ISLAND AVE., LONG ISLAND

(A) APARTMENT HOUSE ZONE
APPLICATION FOR PERMIT

Memorandum from Department of Building Inspection, Portland, Maine

Island Avenue, Long Island--(Assessors Lot No. 93-E-15)--Construction of roof over existing platform on rear of building for Marguerite McKenney by the owner--7/31/51

LAYOUT of Margaret A. Makenney City
Rear Island Ave - Long Island
Assessors Plan 93-E-15
Scale: 1" = 10'

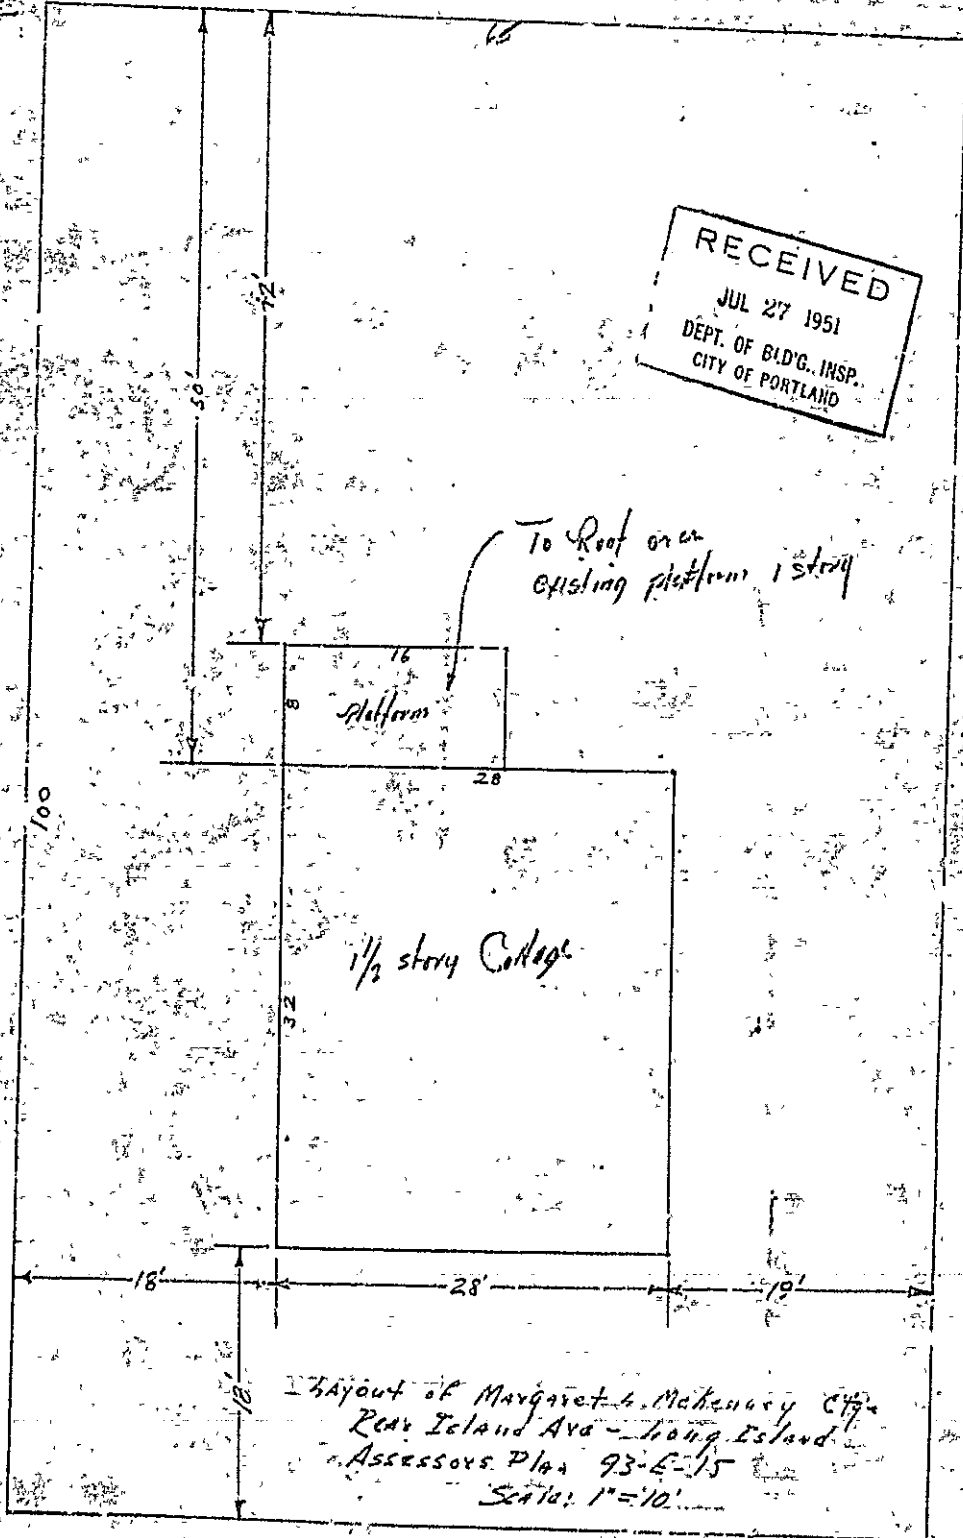
4x4-8' span = 728"

$$\frac{728}{4 \times 8} = 22 \text{ " per sq ft}$$

4x6-8' span = 1752"

$$\frac{1752}{4 \times 8} = 55 \text{ " per sq ft}$$

The 4x4 plate indicated in the application on an 8' span for support of the outer ends of the rafters is not adequate for the roof load involved. Not less than a 4x6 on edge or two 2x6's side by side on edge are required for this purpose. The permit is issued on the condition that such construction will be provided.

Apparently an intermediate 4x4 post besides the two corner posts is to be provided for support of the plate. Care will need to be taken to make sure that there is a support beneath the sill where this intermediate post is to be located.
